Report: Deficiency Report
Function: Test, Adjust, & Balance
Date: 05/19/2025
Completed By: National TAB

05-19-25 WAWA #8196 POTTSTOWN, PA

- EF1-1 - Missing Damper

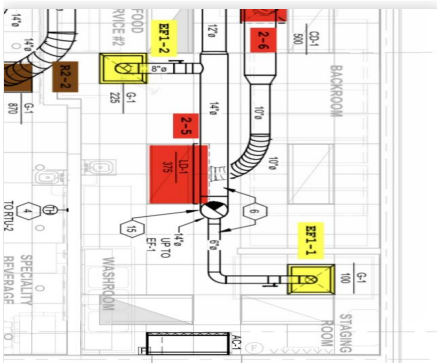
Issue Name : EF1-1 - Missing Damper
Description : Damper is missing or could not be located for exhaust diffuser 1-1 (staging room). Diffuser is currently at 131 CFM (131% design) and cannot be adjusted to design. Recommend installing.
Created By : National TAB **Assigned To :** National TAB - Will Turnbough
Status : Open
Priority : High **Asset Tag :**
Originated Date : 05/19/2025 - Mark Johnson - National TAB
